TRIP REPORT

TRIP REPORT: FOPU

TASK: Condition Assessments, and Analysis of the Jimmy Carter Depot

Cinder block added to stabilize deteriorating brick columns

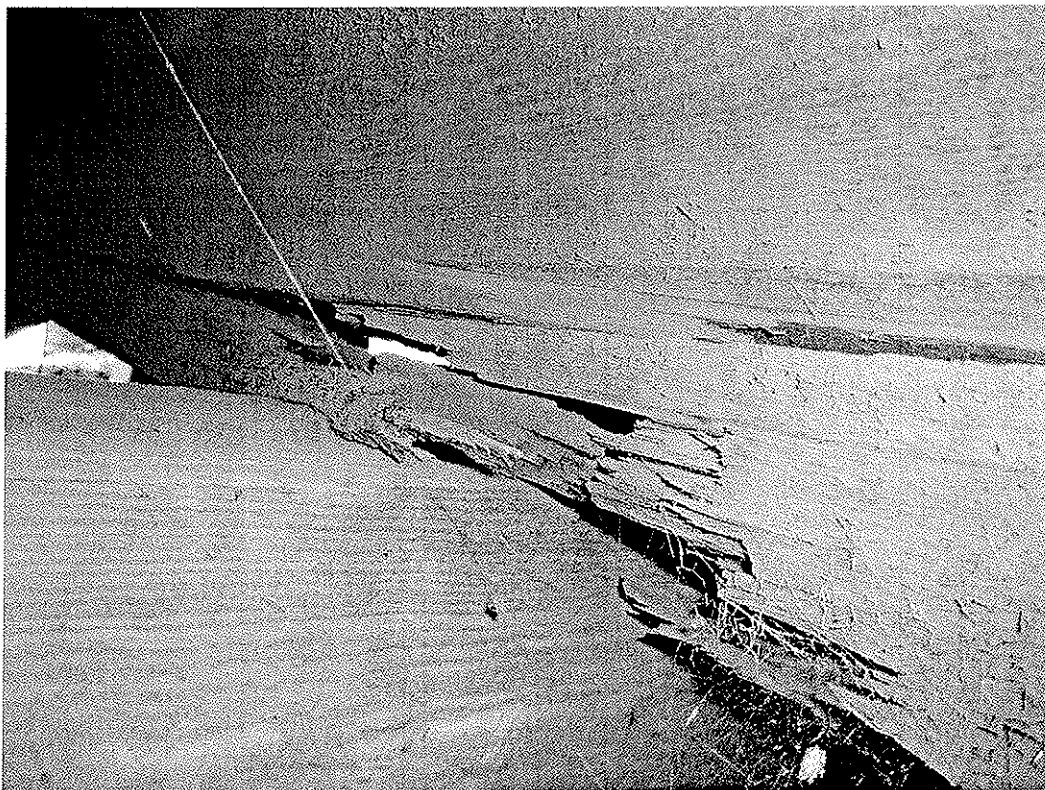
Approximately 11:00 AM a review of the Jimmy Carter National Historical Site Train Depot was begun. The building is a one story wood framed structure that has had stabilization problems. Cinderblock columns have been added next to the sides of the deteriorated brick columns, with wood wedges inserted on top to stabilize the floor structure. The columns range in size from approximately one foot by one foot to two feet by one foot. The columns appear to be constructed of a red clay brick and lime based mortar. The existing cinder block columns appear to be in sound condition and there is no indication of settling of these columns. The park plans to remove the cinder block columns to restore the historical appearance of the structure. The brick columns will require rebuilding prior to this action.

6-inch x 8-inch girders under floor joist

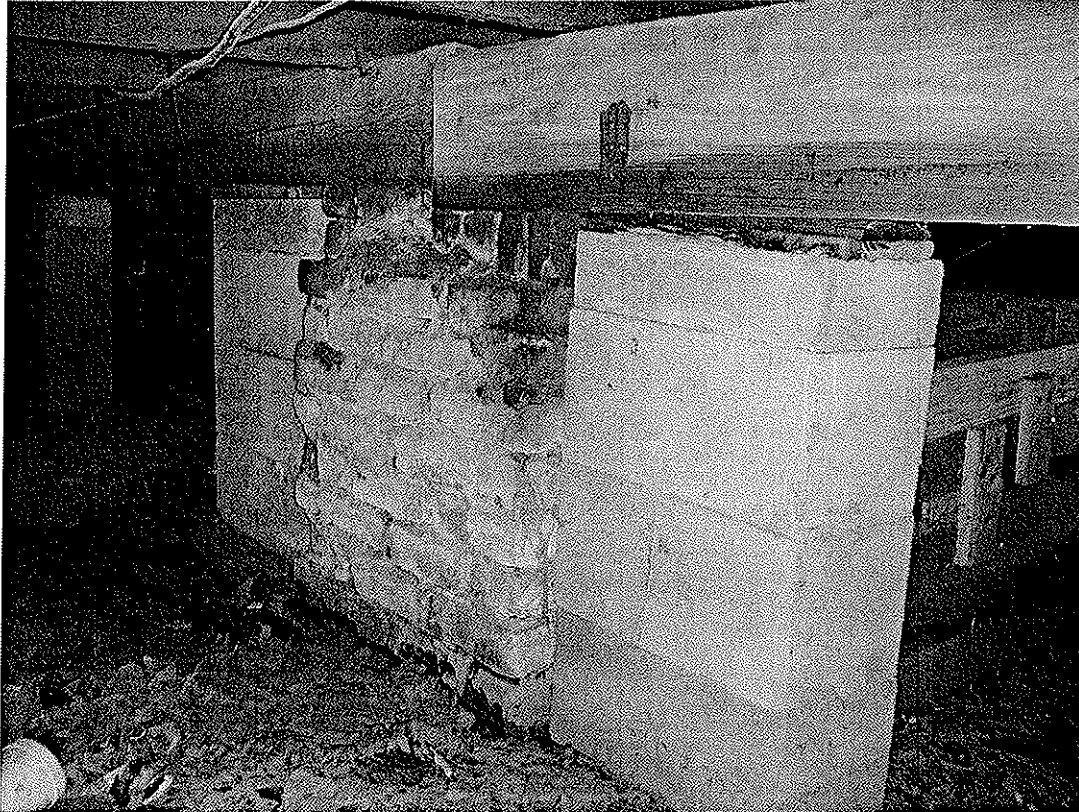
The girders and beams are largely in good condition. The maximum span of the girders between the columns should not exceed 8.3-feet from edge of column to edge of column to maintain the 100 psi of live load requirement.

On the North side of the building near the rail road tracks, several of the joist ends that were notched in to the girder instead of setting on the girder have come out of the notch. A ledger should be installed to hold up the loose ends.
